**20 Nolan Park Renovation**

RFP Responses to questions received from proposers

**Subject:** Responses to questions received from RFP Proposers for the 20 Nolan Park Renovation

20 Evans Road, Nolan Park  
Governors Island

# Model: TCMBM0108JA11N4 - DIMENSIONS

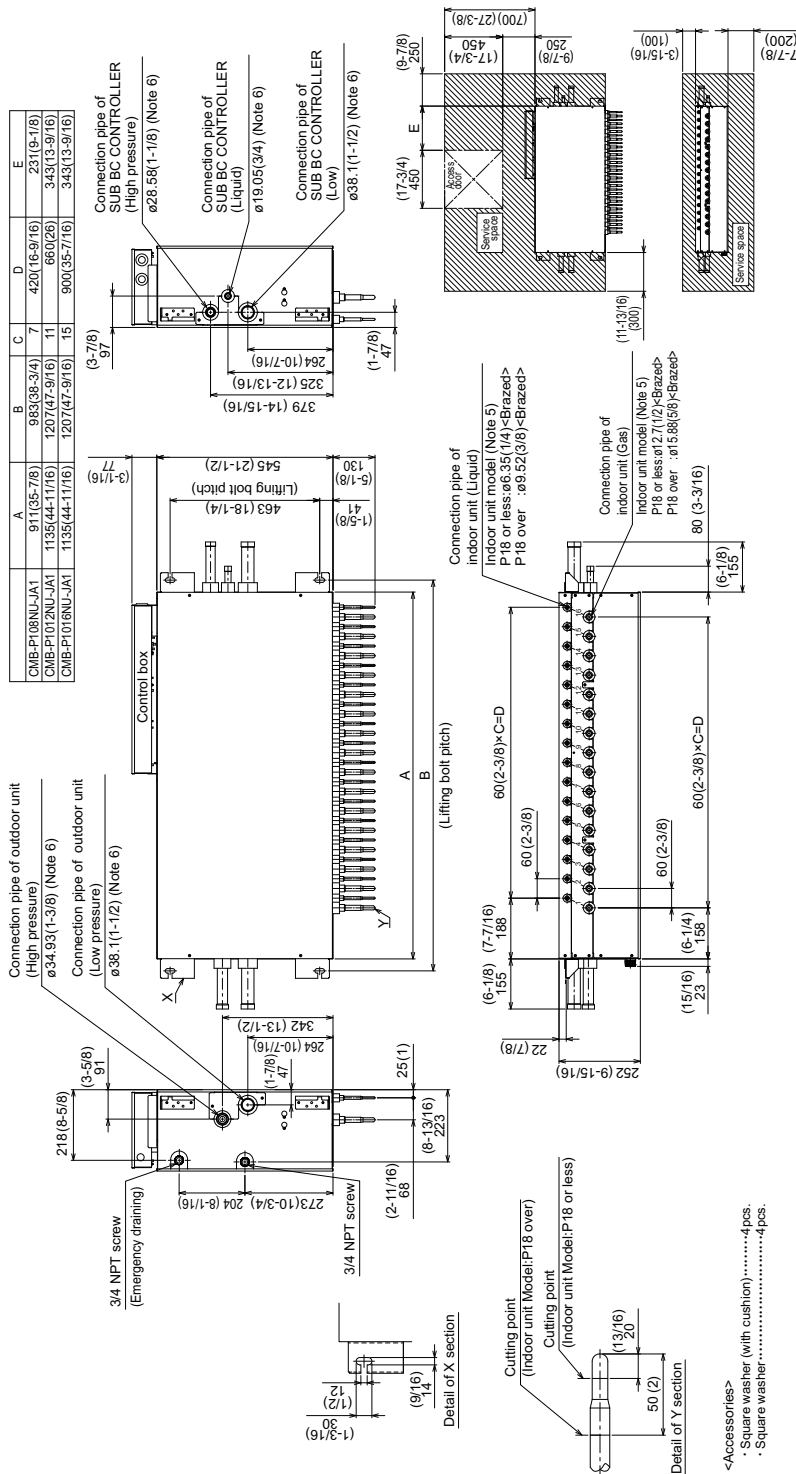
14	10.08.2021	The Refrigerant piping for the VRF system is not clear please update flow diagram showing the quantity of piping runs .	See attachment A which provides an updated VRF piping diagram with additional information.	Attachment A

Attachment B: Branch Box Update
